215130.101Rev E

STRUCTURAL FEASIBILITY REPORT

BASEMENT CONSTRUCTION

**43 BURGHLEY ROAD
NW5**

CONCEPT CROSS SECTION

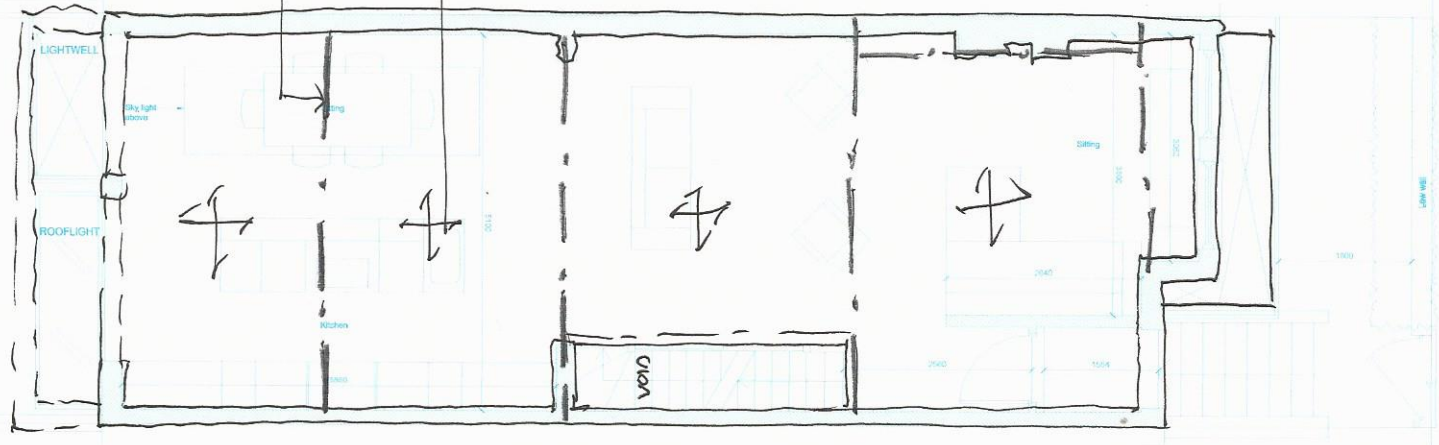
Section 4.11 of the Camphill Reith Audit dated March 2018 states that "estimates of heave are predicted on the assumption that the basement slab is to be suspended. This is at odds with the SFR which show a ground beam slab."

The cross section has been clarified to show a suspended slab, and the indicative calculations augmented accordingly.

NOTE - WEDGE PRECAUTION
REQUIRED UNDER PILEMENT
SLAB

INDICATIVE RETAINING WALL DESIGN

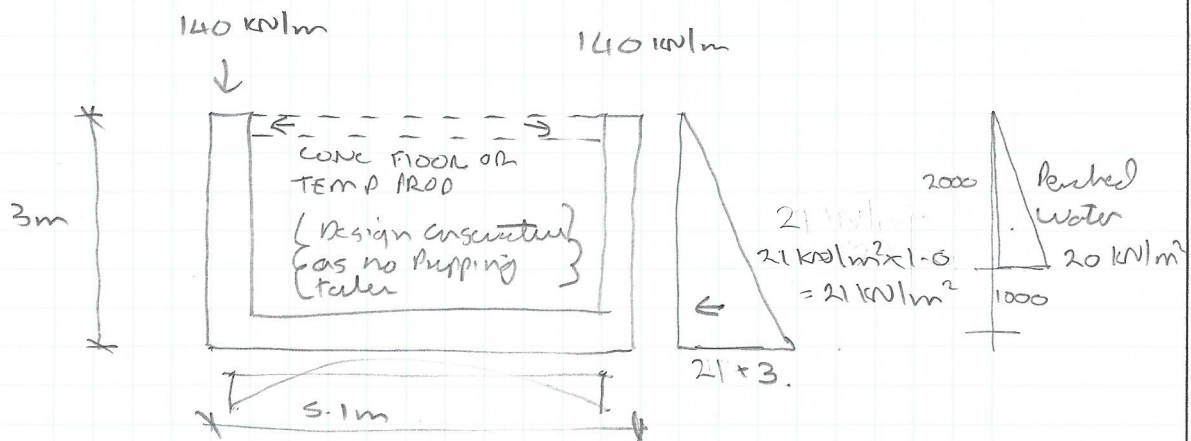
Revision of Indicative Calculations to include alteration of Phi value and inclusion of perched water table loadings.

K_a updated to 0.42

- Soil γ_s 16 kN/m³ $K_a = 0.42$ $K_0 = 1.00$
 Soil wet 21 kN/m³ $K_a = 0.42$
 Water Behind Made Ground =
- BUILDING LOAD TO SIDE WALLS \approx 140 kN/m (lin).

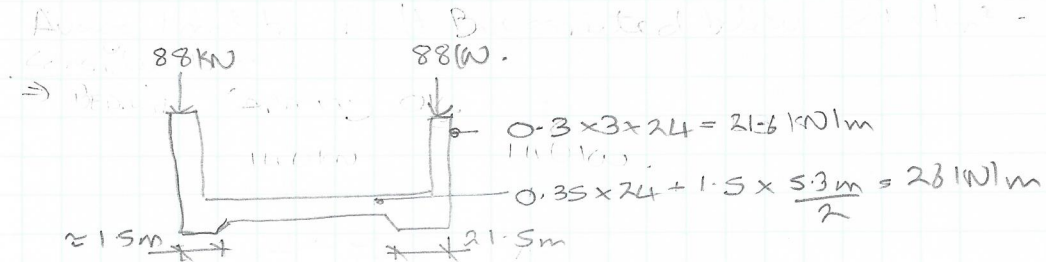
Subsequent to the forth issue, the indicative calculations have been amended to result in a bearing stress under the basement walls of approximately 90kN/m^2 as recommended by the BIA. Indicative calculations have been revised accordingly.

Consider Base - Bearing on the wall edge to be 90 kN/m^2 as noted in B1A.

$$\text{Total} = 88 + 21.6 + 26 = 135 \text{ kN/m} = 1.5 \text{ m wide Toe} \quad 30 \text{ kN/m}^2$$
